## **Planning and Zoning Commission Meeting**

Application for a Conceptual Plan Approval – Richardson St. Plaza

PLANNED DEVELOPMENT OVERLAY PLAT  
**RICHARDSON STREET PLAZA**  
 A REPLAT OF A PART OF TRACT O, "STEWART COMMERCIAL PARK,"  
 SMITHVILLE, CLAY COUNTY, MISSOURI  
 NE ¼, SEC. 27 - T53N - R33W & NW ¼, SEC. 26 - T53N - R33W

Application for a Plat Approval – Richardson Street Plaza Final Plat– 3 lots

PLANNED OVERLAY DEVELOPMENT PLAT

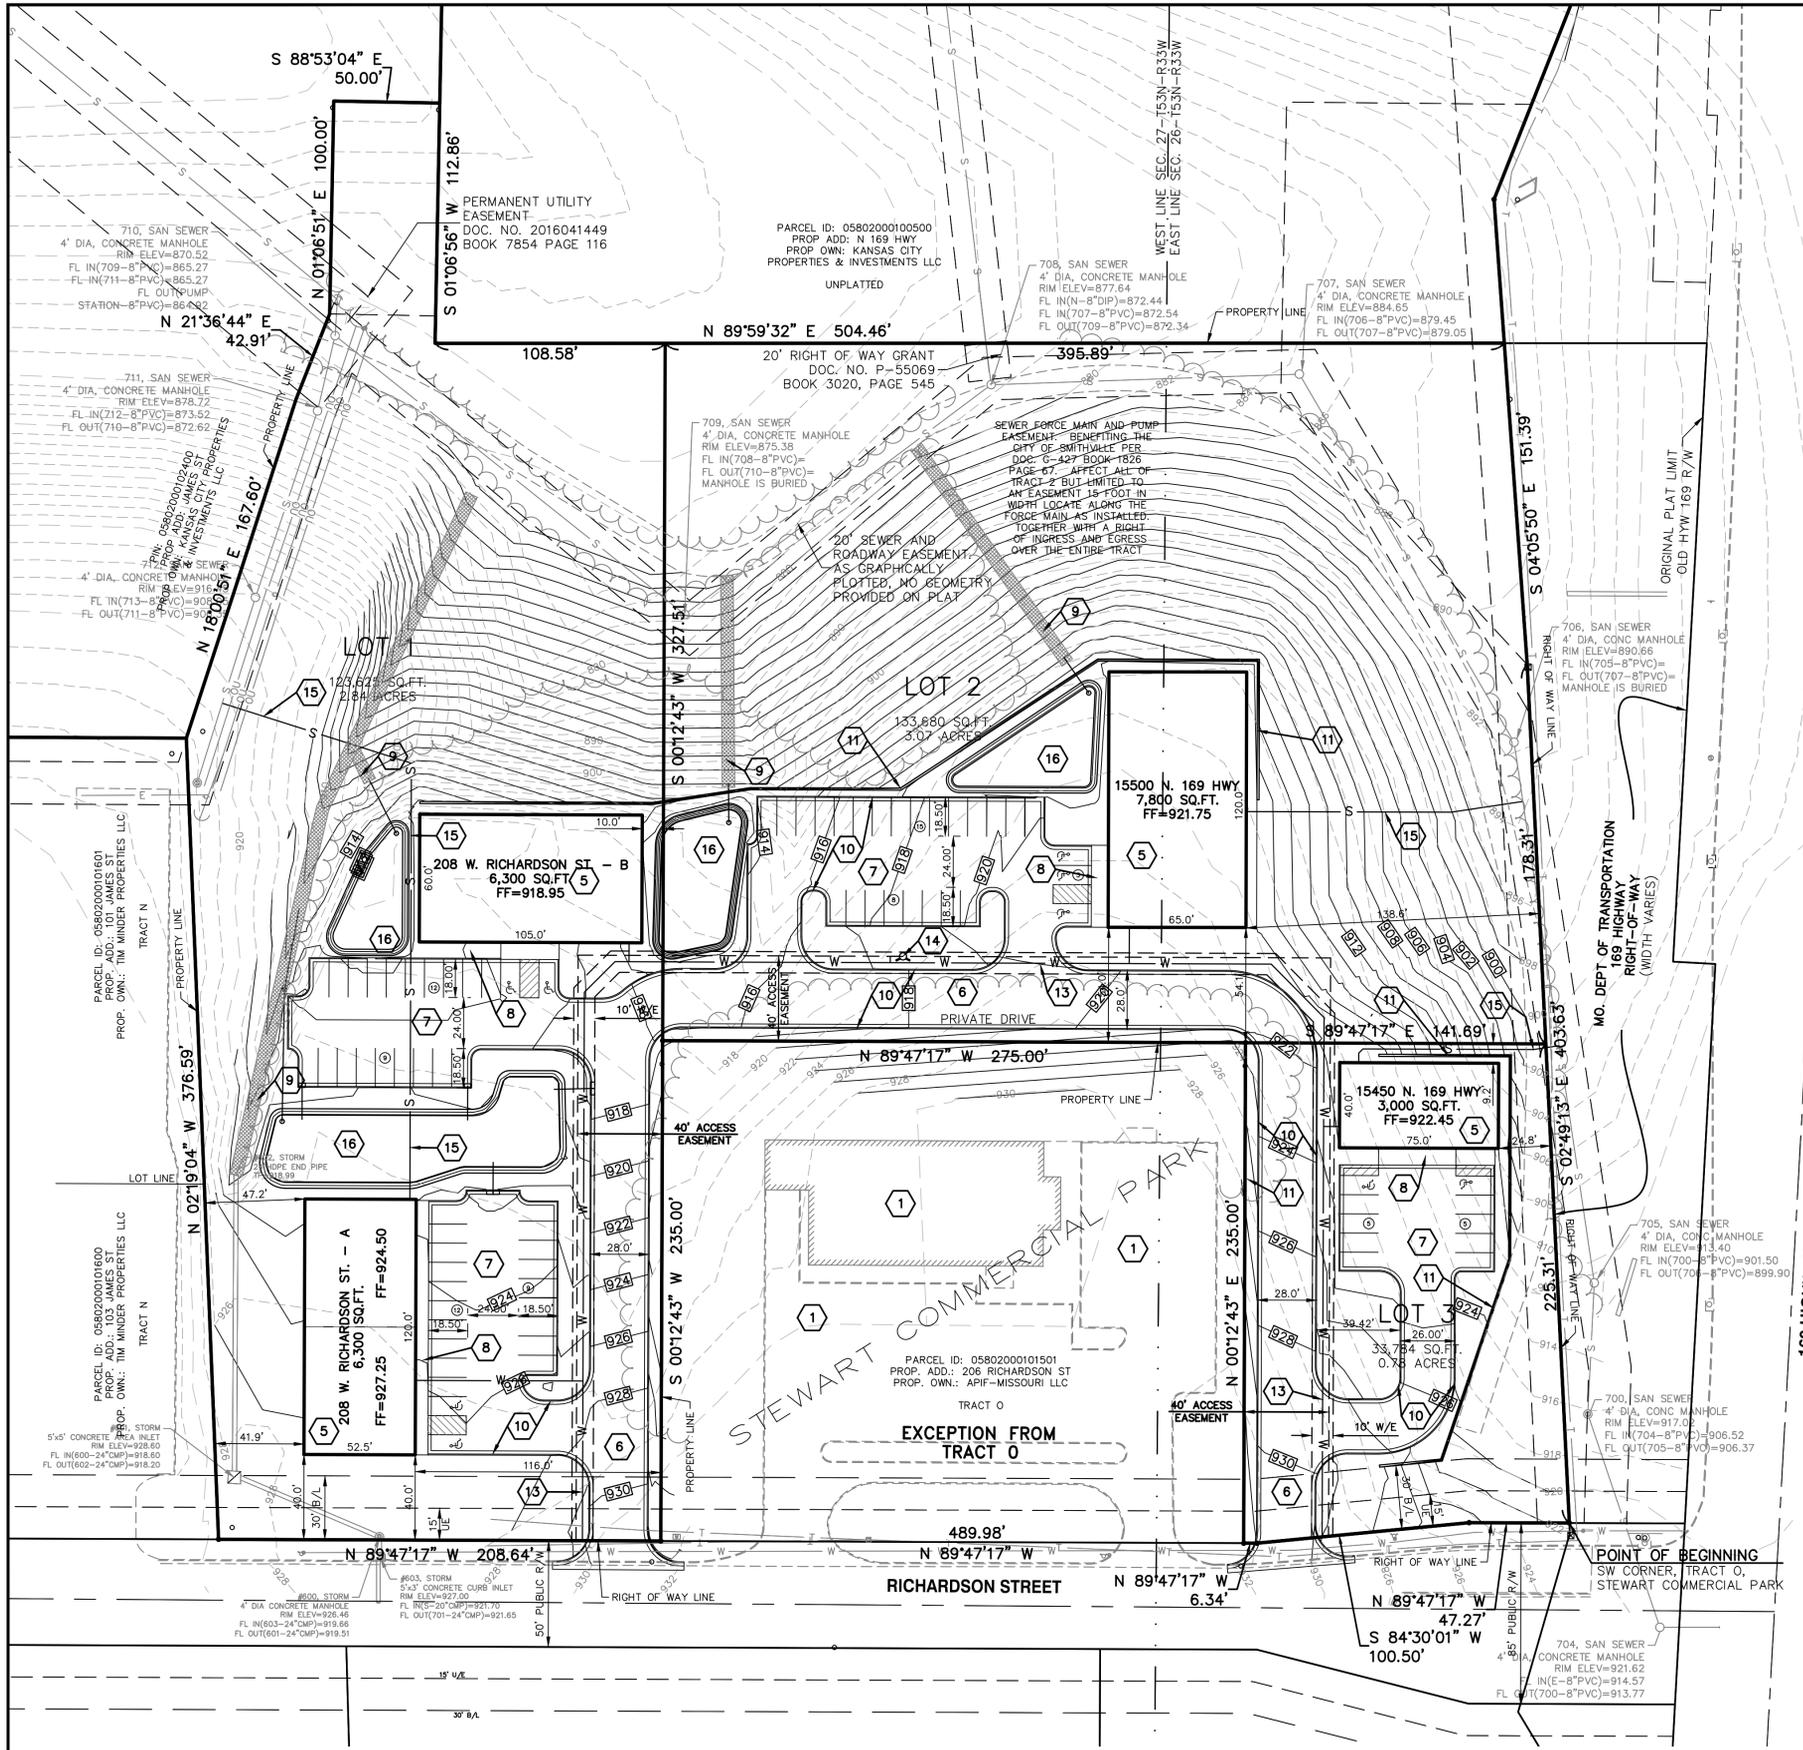
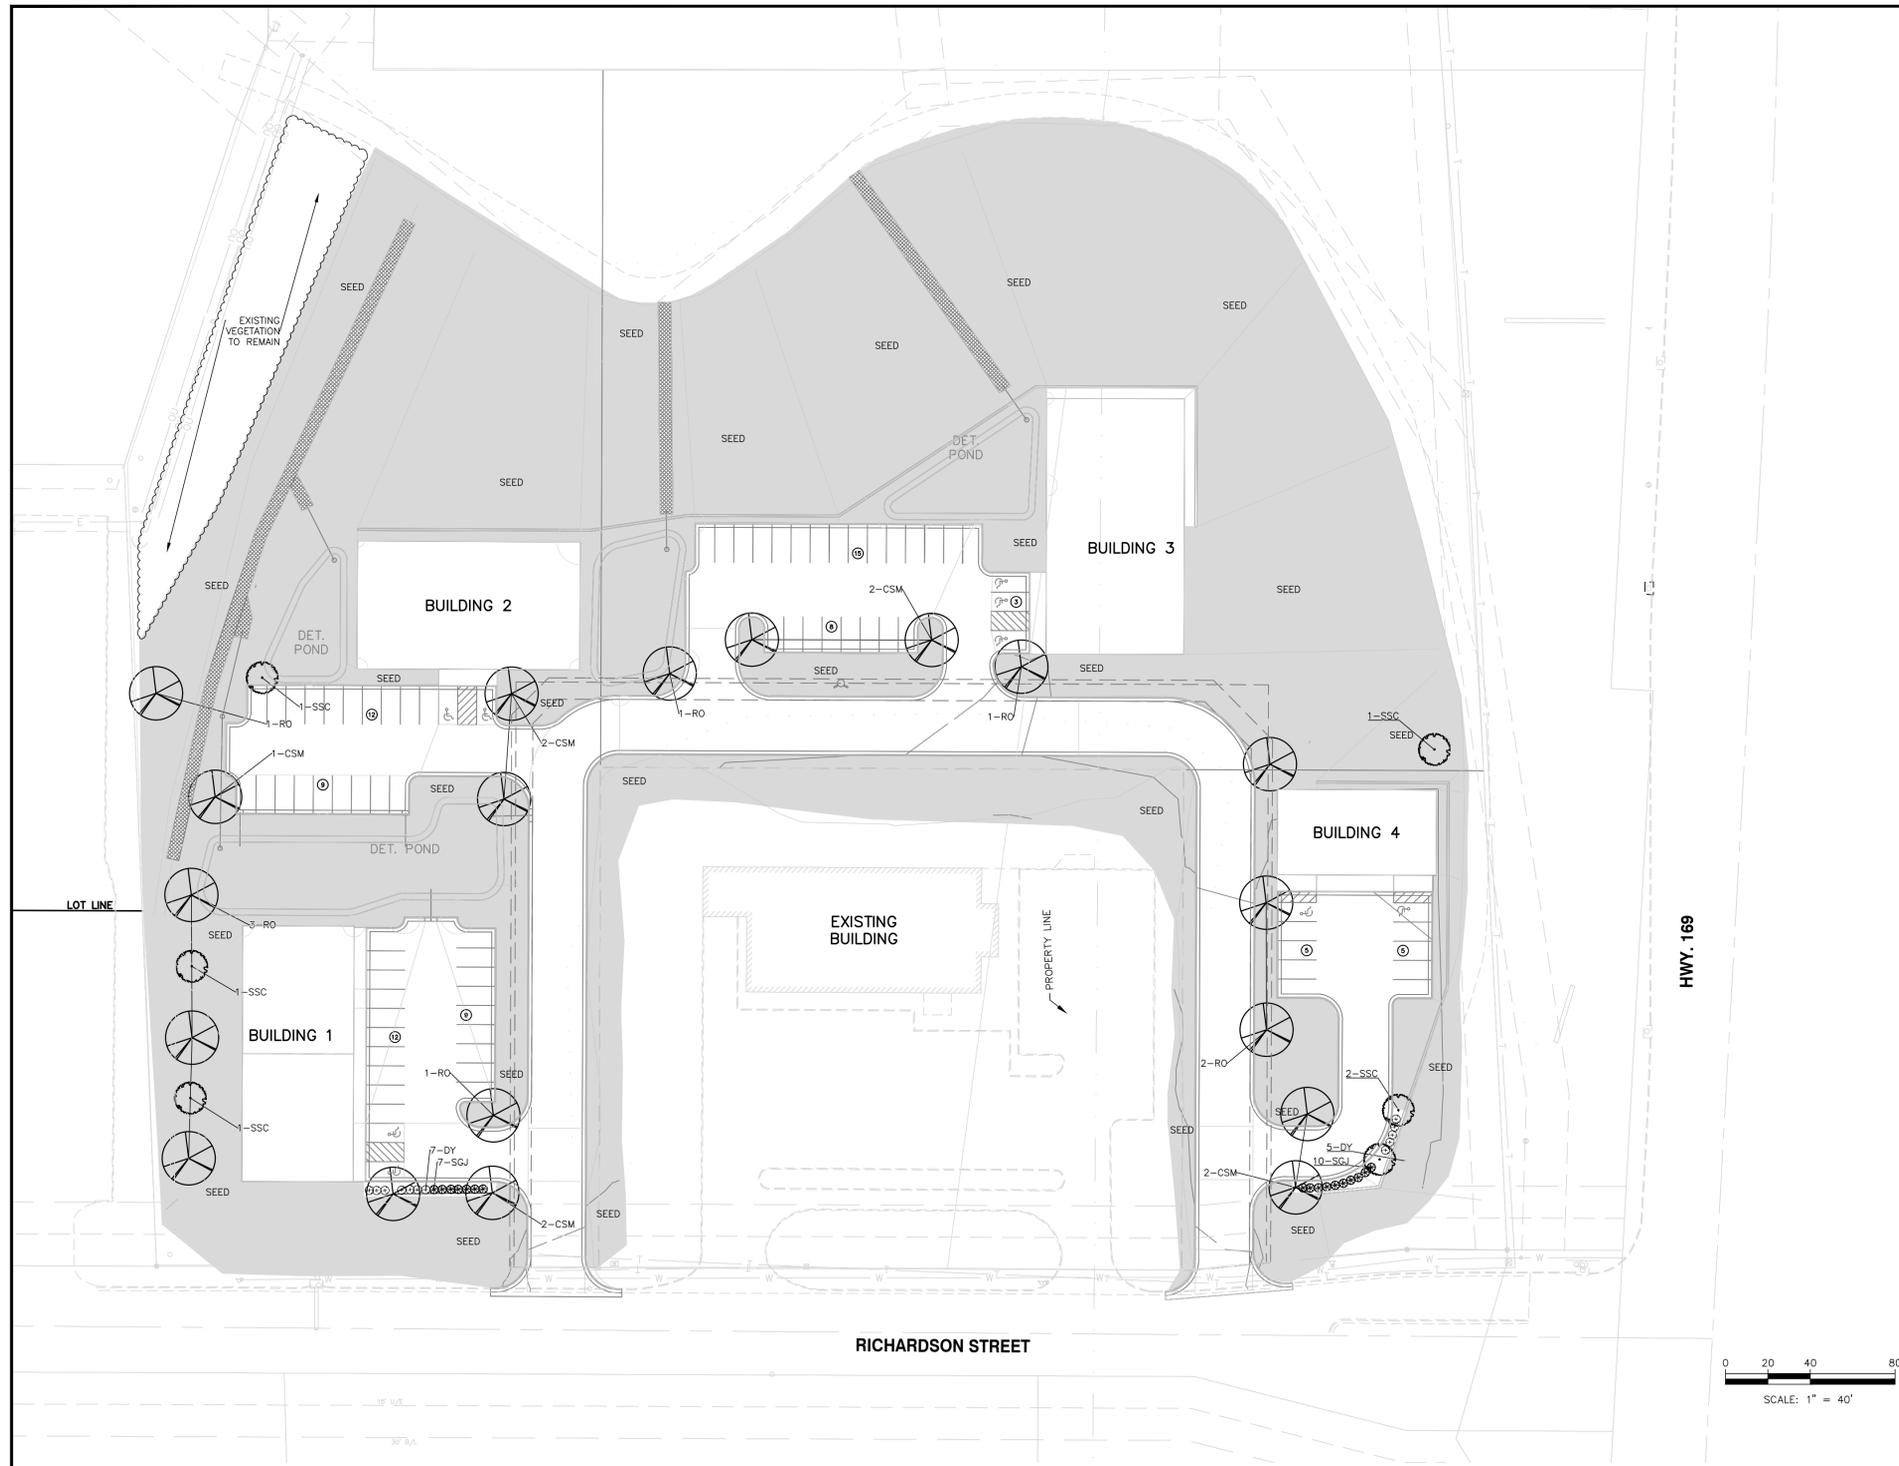
**Development placement specifically avoids the deep ravine area to the north of the proposed pad sites and leaves, as much as possible for utility construction, the existing good vegetation in the ravine area.**

**has no specific tenants identified, but there exists adequate parking for the four proposed buildings and uses. Any minor variations to building size could impact the required parking, but in no event will a tenant be able to increase a building footprint or change a use without adjusting parking to meet these requirements.**

**Development leaves ample spacing between the proposed buildings, as well as the existing facilities.**

**The Development is without tenants and seeks to create the overall look of the development without limiting potential tenants. Therefore, this Conceptual plan will require independent site plan reviews of each proposed building, and must meet the site plan requirements in existence at the time of construction, in particular only to the buildings. All other elements are identified and required as show herein.**

**Development prepared and submitted a Stormwater Study and has agreed to construct the required detention structures when the project begins.**

**Development will include a contribution to the installation of a traffic light at the 169 & Richardson intersection. Developer submitted a Traffic Study which indicated that a light met two of the traffic warrants at the intersection NOW, and that further traffic would reach**

**the levels of other warrants, so a light was needed. With a recent new development proposal on the SE corner of 169 and Richardson, the percentage of each developments contribution to the light is still under consideration by the City and MODOT but will be completed for the Board of Aldermen to approve in a Development Agreement at the second reading of any approved ordinance.**
